AGENDA
BIRMINGHAM DESIGN REVIEW BOARD MEETING
MUNICIPAL BUILDING-COMMISSION ROOM-151 MARTIN STREET
WEDNESDAY – February 15, 2017
******* 7:15 PM*******

DATE: February 10, 2017
TO: Design Review Board
FROM: Matthew Baka – Senior Planner
SUBJECT: Sign Review – 200 Chester – Baldwin House

54" x 26" Single Sided 12" Sign Comp
 LED Lit
 Painted 1 color
 Single post installation
 Vinyl Graphics on Face - PMS Color 576U

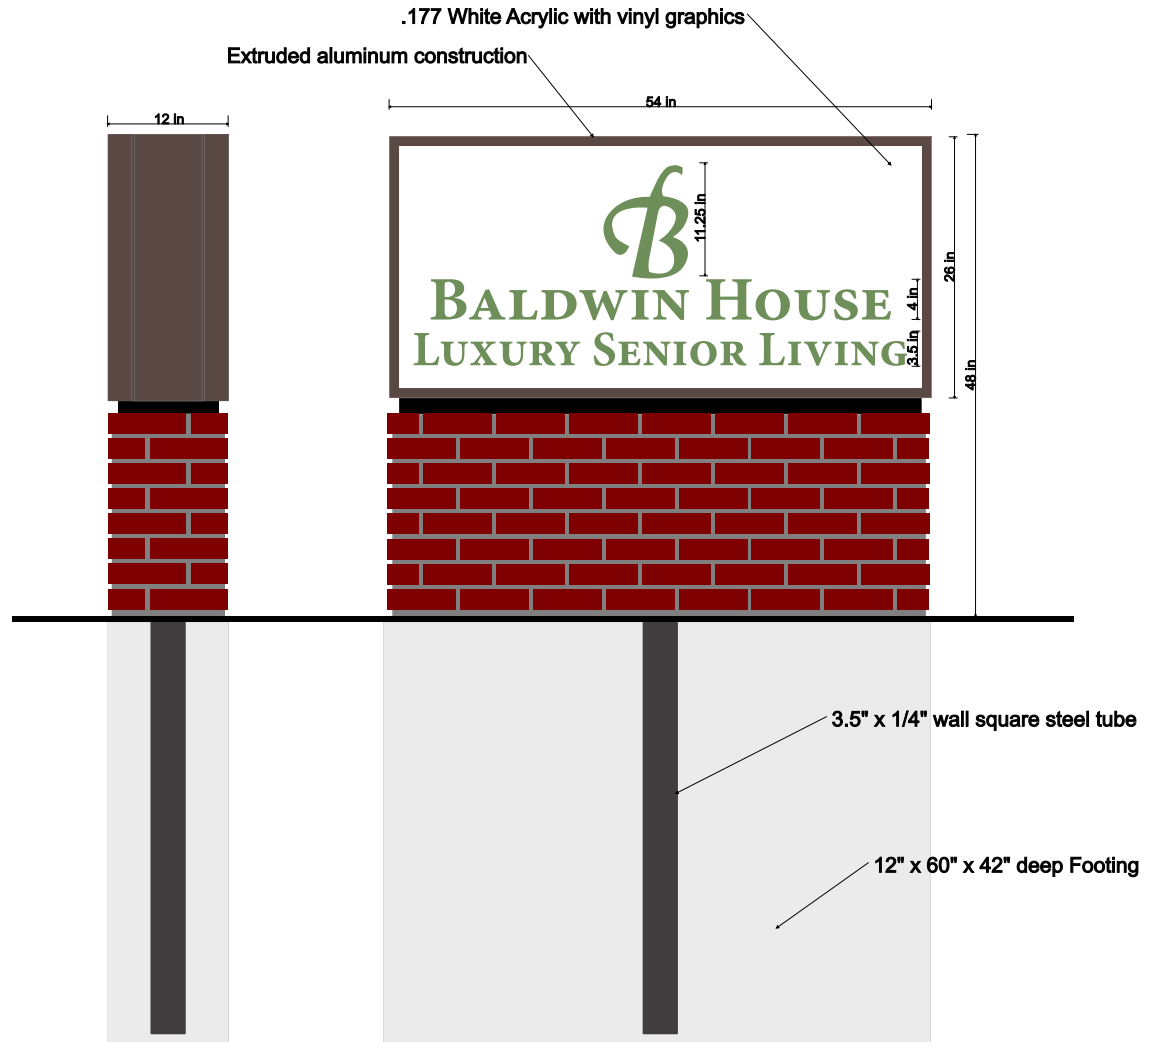
The applicant proposes to install a one sided illuminated ground sign on the northeast corner of the parcel.

Signage regulations for residential zones are governed by *Table D: Permanent Residential Sign Standards*. Residential signs are not restricted by the principle building frontage as commercial properties are provided that they comply with the regulations of Table D. *In accordance with Section 86, Article 1.0, Table D of the sign ordinance, the total of all ground signs must not exceed twenty square feet of sign. The proposal meets this requirement.* The sign is proposed to be mounted 4' above grade. *In accordance with Section 86, Article 1.0, Table D, no ground sign may be more than four feet above grade. The proposal meets this requirement.*

The proposed sign is to be constructed of an aluminum cabinet with an acrylic face and a brick base. The graphics are proposed to be vinyl letters. **Typically the DRB requires that ground signs are constructed with push-thru or routed letters rather than vinyl.**

The applicant proposes to internally illuminate the sign with LED lighting panels.

The Planning Division recommends that the Commission consider a motion to APPROVE the Sign review application for 200 Chester with the condition that the vinyl letters be upgraded to routed or push-thru letters.

1. The applicant revised the sign plan to provide routed or push-thru letters.
